JONES & BEACH ENGINEERS INC.

**RE: Response Letter 3 – Altus Engineering & TAC Comments
212, 214, & 216 Woodbury Ave., Portsmouth, NH, 03801
Tax Map 175, Lots 1, 2, & 3
JBE Project No. 21254**

We are in receipt of comments from Eric Weinrieb, P.E., Altus Engineering, dated October 25, 2022, and from Stefanie Casella, Portsmouth Planning Department, dated November 14, 2022. Review comments are listed below with our responses in bold.

SHEET 10 OF 23
JBE PROJECT NO. 21254

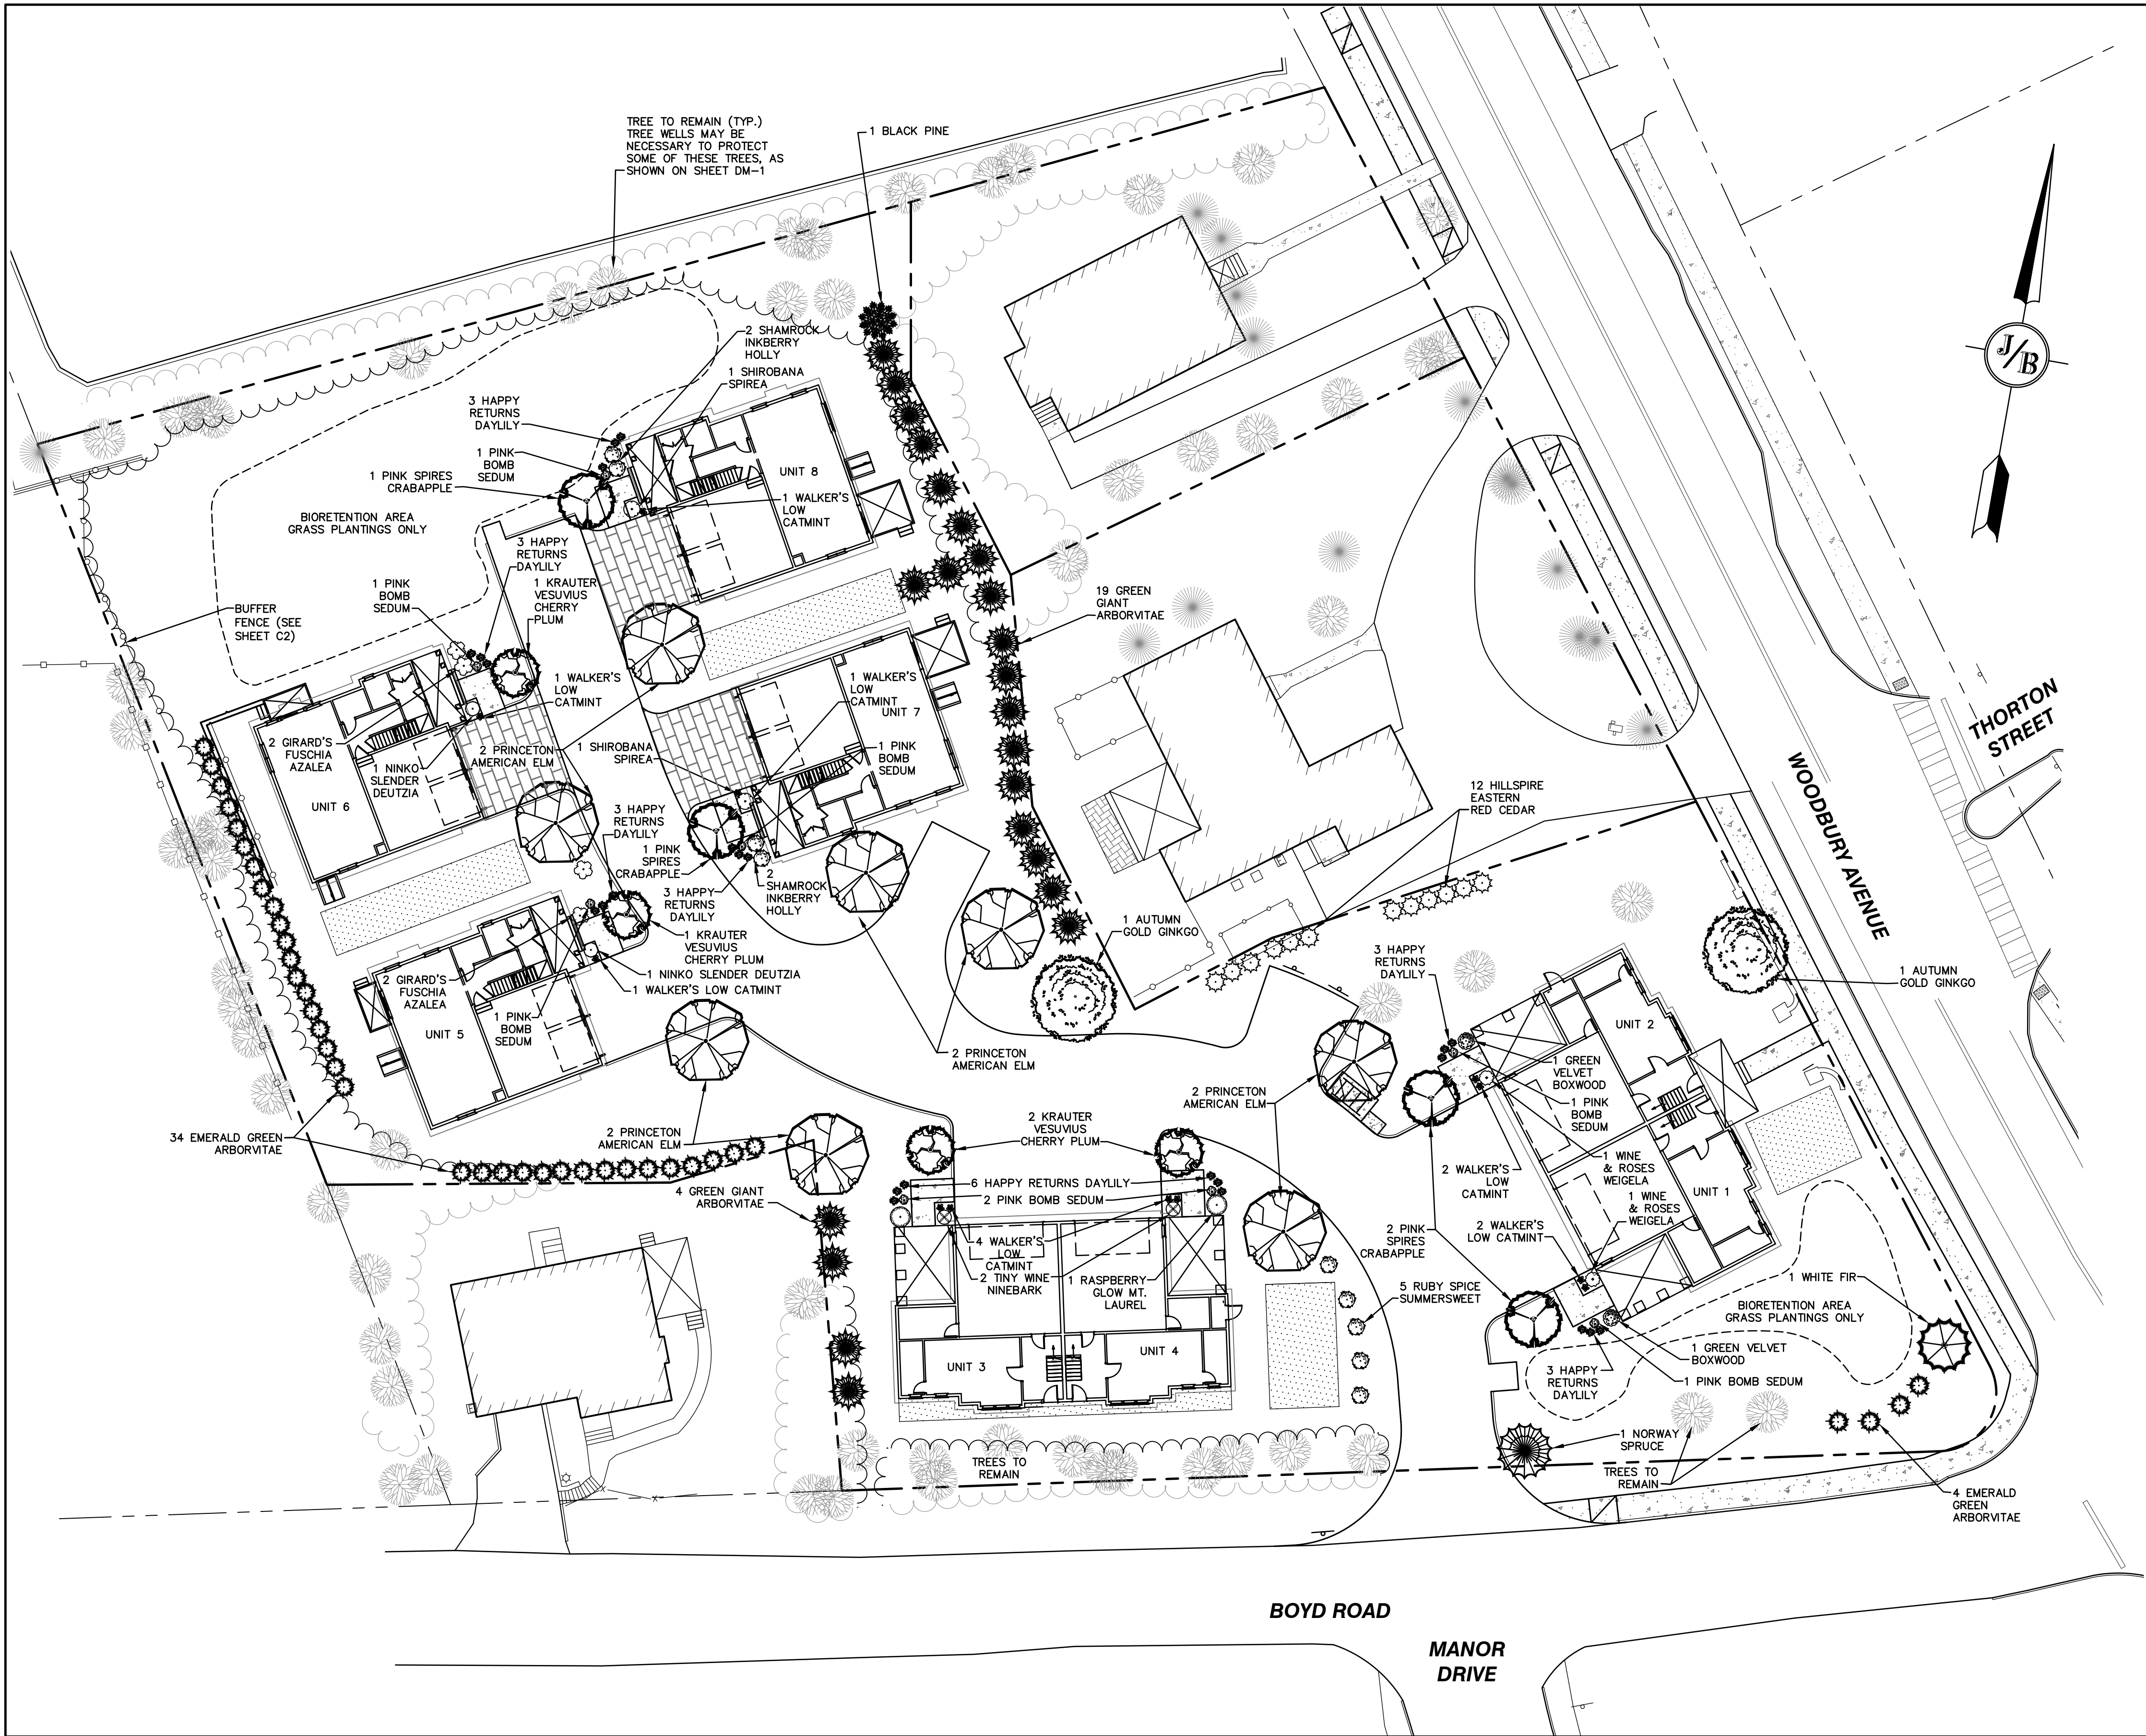
4. Based on the proposed grading, it appears that some of the specimen trees scheduled to remain may be disturbed by the construction activities near bioretention system 1. The Designer should provide the spread on the specimen trees and obtain a letter from the landscape architect certifying that the trees will not be damaged by the construction activities. Issue partially addressed. The landscape architect has submitted a letter indicating that the trees adjacent to the pond and roadway will survive the construction activities. The site grading has been modified. The Designer should add notes to the effect that if trees scheduled to remain need to be removed or become unhealthy, additional trees will need to be planted to the satisfaction of the Planning Department.

RESPONSE: See Note #22 on Sheet L1.

21. SEE TYPICAL PLANTING DETAILS ON SHEET D5.
22. IF TREES SCHEDULED TO REMAIN NEED TO BE REMOVED OR BECOME UNHEALTHY, ADDITIONAL TREES WILL NEED TO BE PLANTED TO THE SATISFACTION OF THE PLANNING DEPARTMENT.

SHEET 17 OF 23
JBE PROJECT NO. 21254

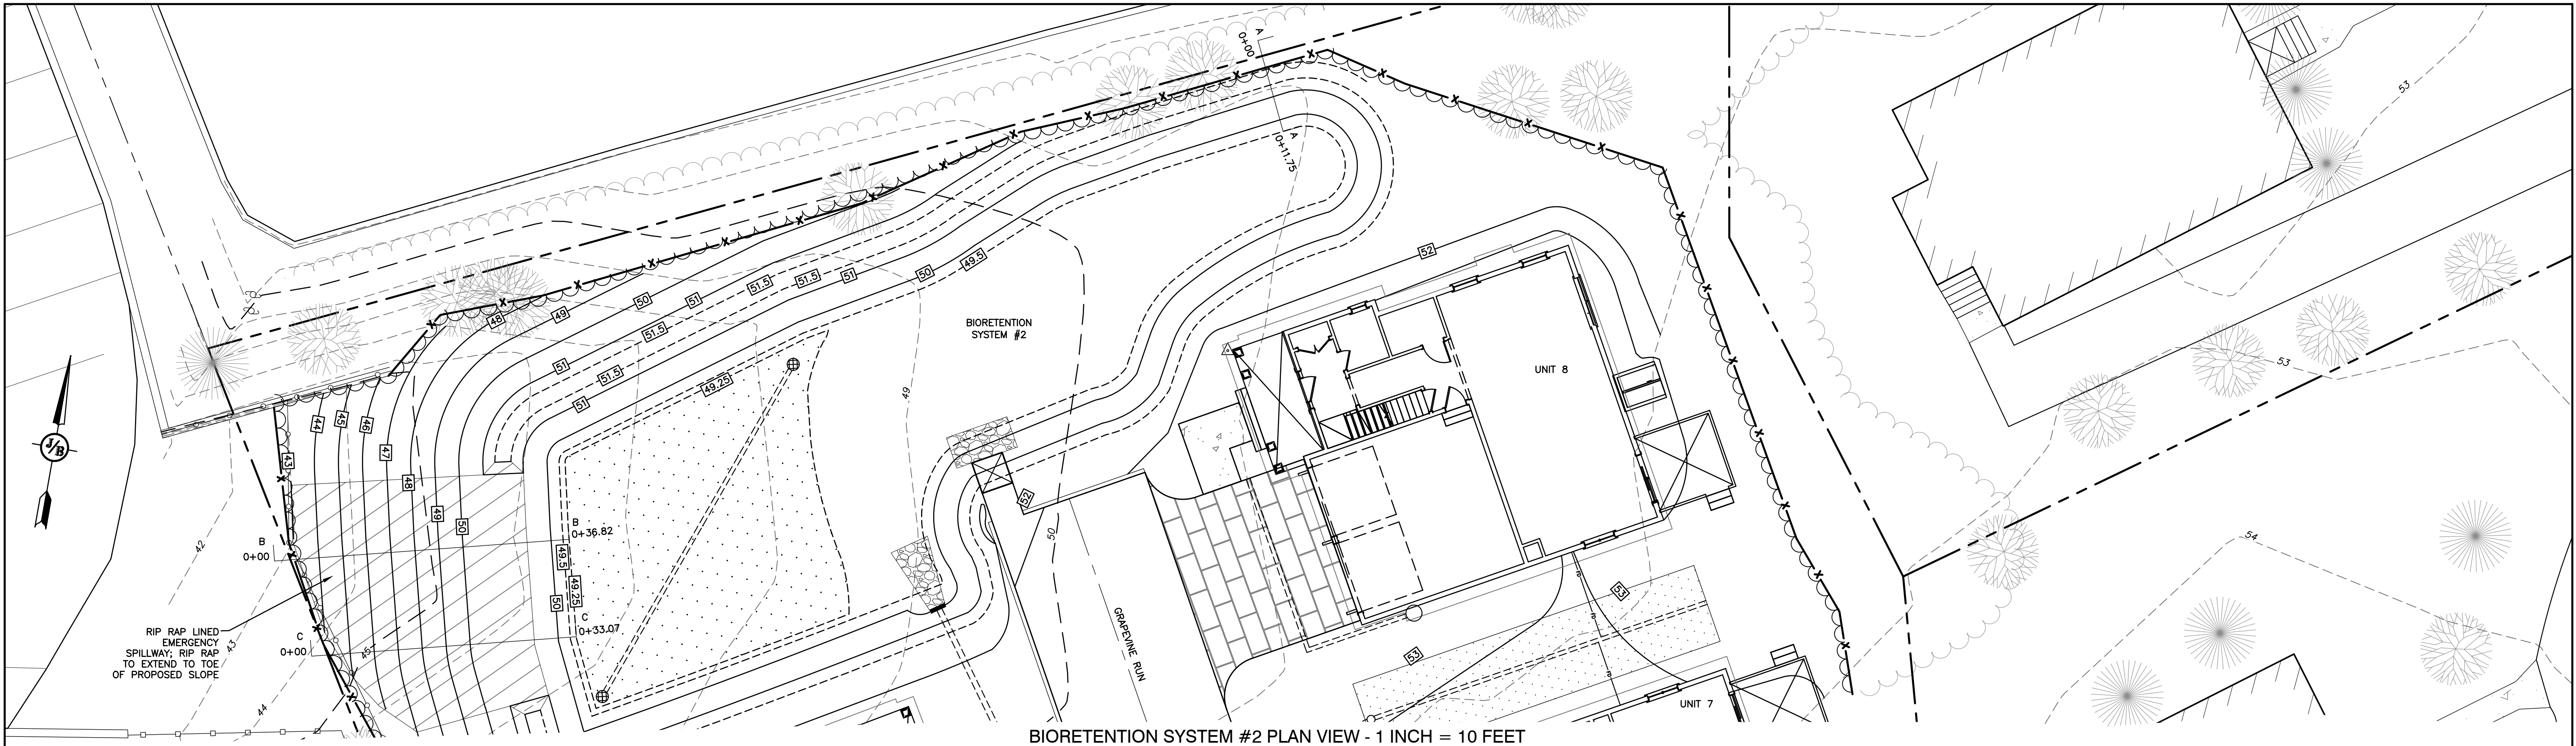
2. *The Designer has added sediment forebays to the surface treatment devices.*

RESPONSE: In order to save space, the sediment forebay for bioretention #2 has been replaced with a Pre-Tx curb inlet device. A detail for this device is on Sheet D6. This provides pre-treatment as well. Bioretention #1 still has a proposed sediment forebay.
